# **WILDWOOD ADDITION TO PINEHURST**

## **SUBDIVISION**

APPLICATION NUMBER 12 DATE June 2, 2005  
APPLICANT Wildwood Addition to Pinehurst Subdivision  
REQUEST Subdivision

## DETAIL SITE PLAN

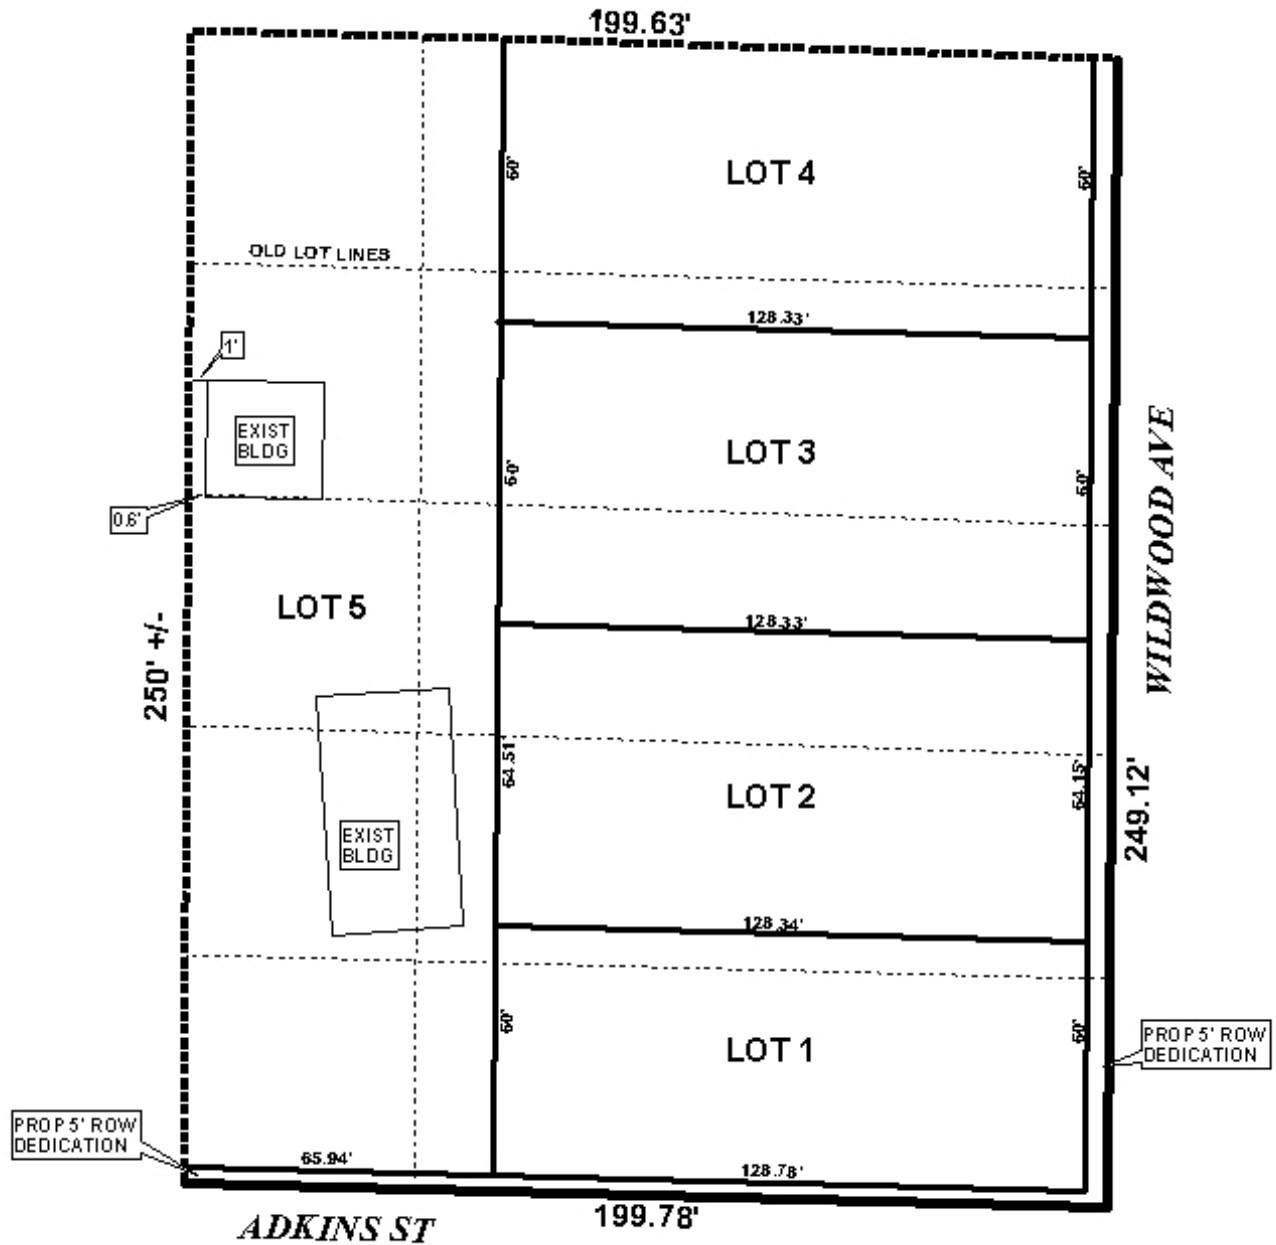
The site fronts Wildwood Avenue and Adkins Street, each of which has a 40' right-of-way and as such is substandard in width. Thus dedication of sufficient right-of-way to provide 50' from the centerlines of those roads should be required, as illustrated on the plat.

While proposed Lots 1 through 4 would meet the minimum requirements of the Subdivision Regulations, Lot 5 would exceed the maximum depth to width ratio of 3.5 (Section V.D.3). The orientation of Lot 5 is also atypical of the neighborhood, where most houses face the north-south avenues, and very few houses are oriented toward Adkins Street. However, there are existing buildings on proposed Lot 5, which are oriented toward Adkins Street; as the applicant intends for the buildings to remain, the unusual dimensions and orientation of Lot 5 can be considered appropriate.

It should be noted that while an existing outbuilding on proposed Lot 5 encroaches on the required side yard setbacks, this appears to have been a pre-existing, nonconforming structure; however, this would need to be verified, or the building removed, before the final plat were signed.

The plat shows the required 25' building setback line for the front of all lots, but does not show the side setback line for proposed Lot 1; a 20' setback from Adkins lane should be shown on the final plat for proposed Lot 1.

With a waiver of Section V.D.3 (depth to width ratio), the plat will meet the minimum requirements of the Subdivision Regulations and is recommended for Tentative Approval, subject to the following condition: 1) the dedication of sufficient right-of-way to provide 50 feet from the centerlines of Wildwood Avenue and Adkins Street, as illustrated on the preliminary plat.
